SUBDIVISION REVIEW SHEET

CASE NO.: C8-2017-0307.4A

SUBDIVISION NAME: The Vistas of Austin, Section 5

CITY OF AUSTIN –DEVELOPMENT SERVICES DEPARTMENT SUBDIVISION APPLICATION – MASTER COMMENT REPORT

THE VISTAS OF AUSTIN, SECTION 5

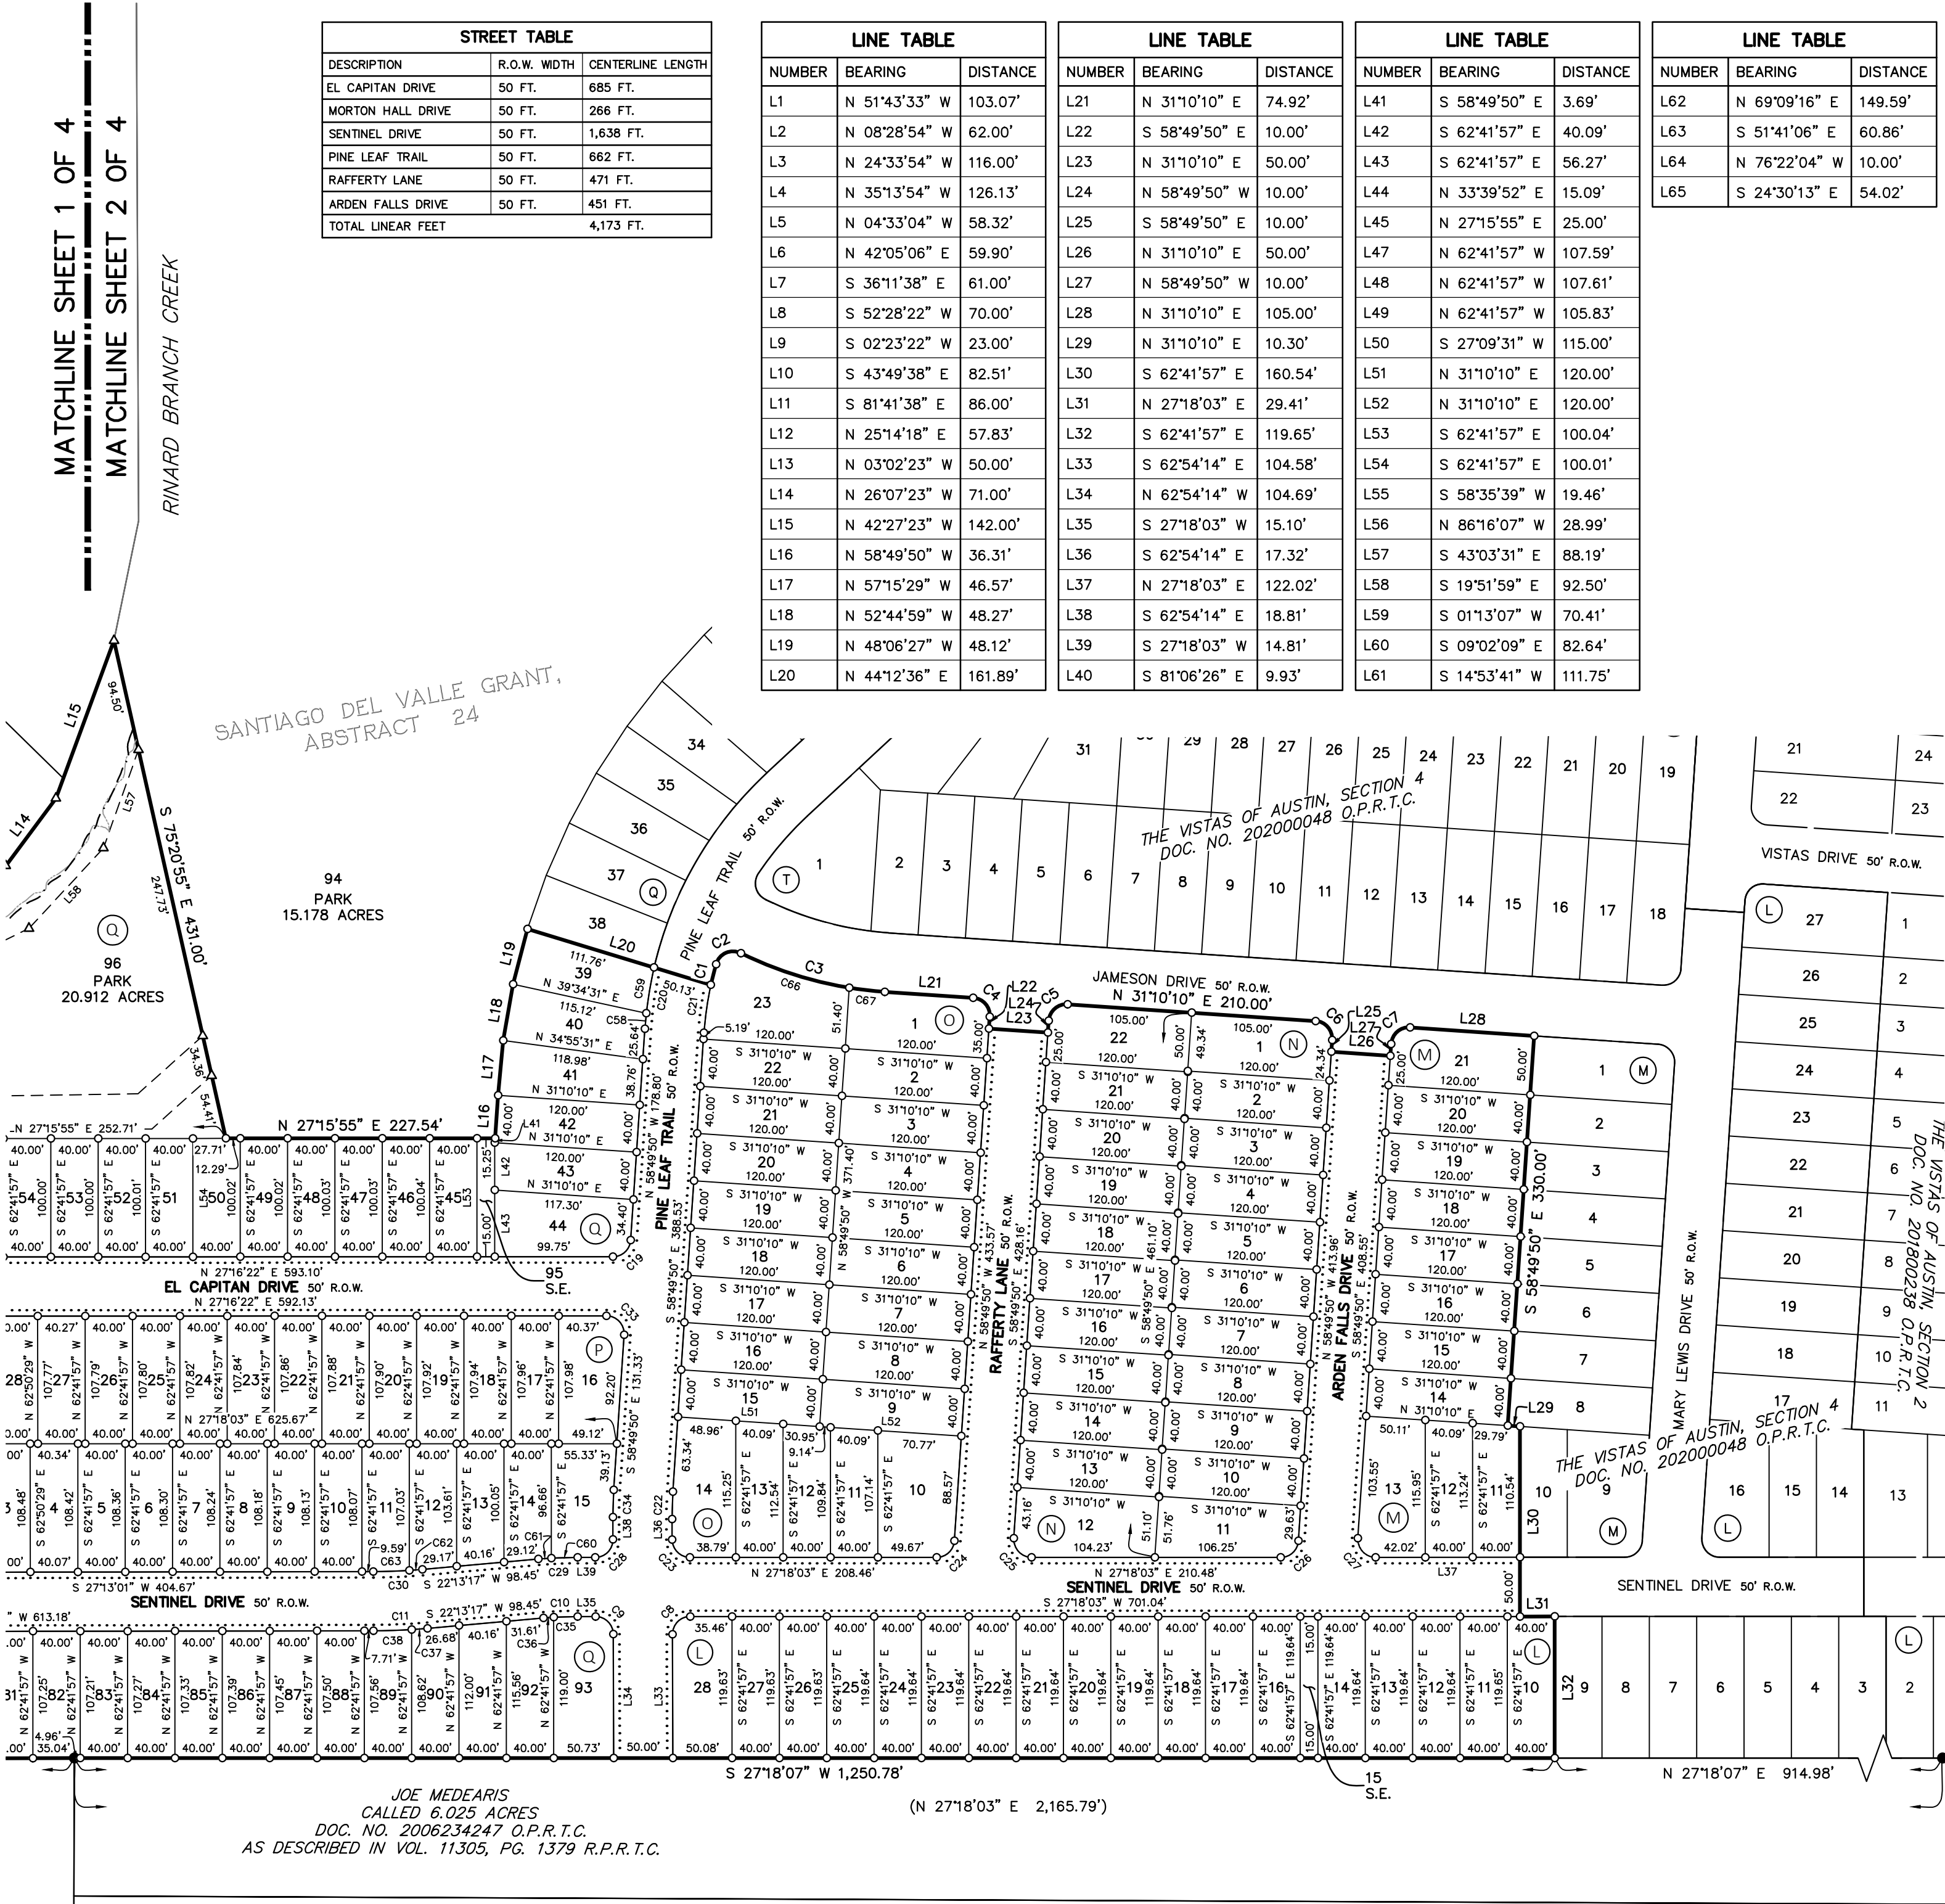
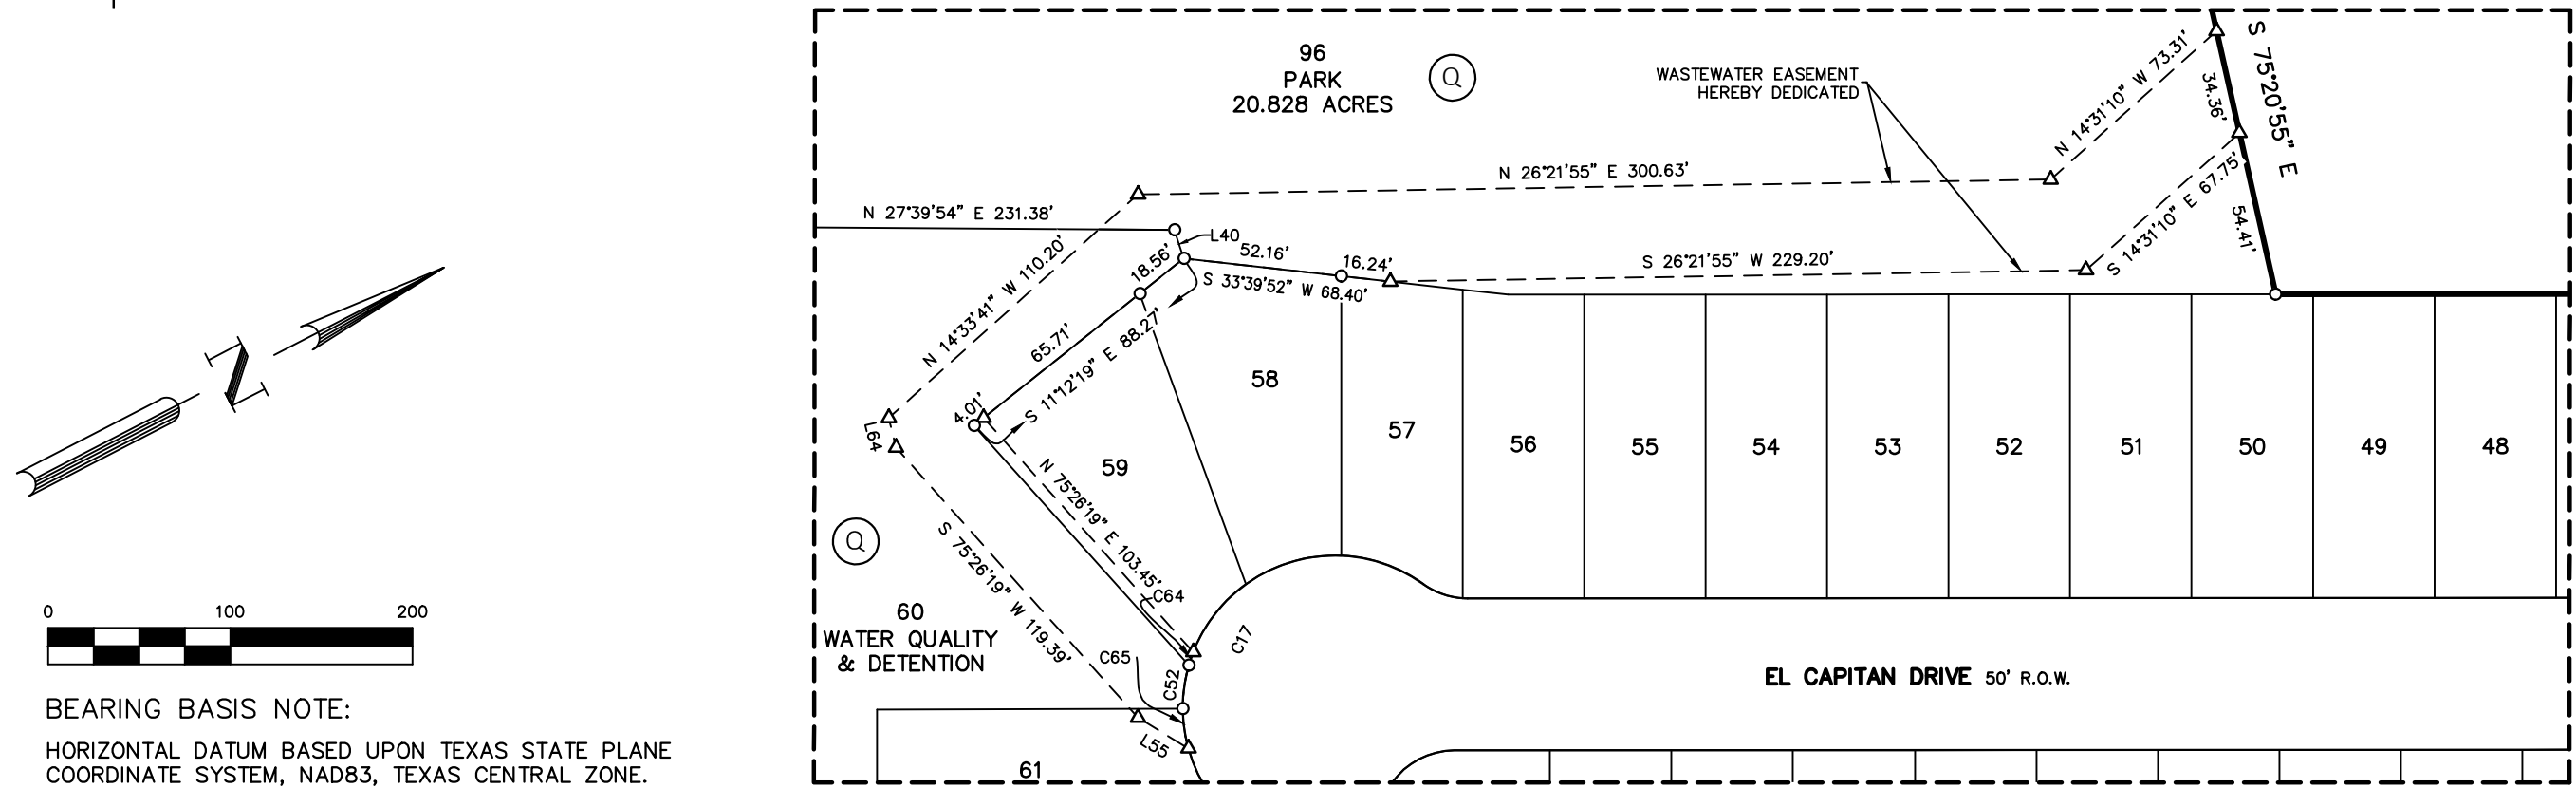
Ten electric distribution, electric telecommunications, and electric fiber easement is required adjacent to all street R.O.W. Show the easements on the face of the plat. Required during project assessment but not shown.

DE4. Label Lot 60 to be a drainage easement.

DE 5. Remove floodplain delineation. Refer to DCM 1.2.6.

Update 2. Repeat comment. (The wetlands are not shown in the plat.)
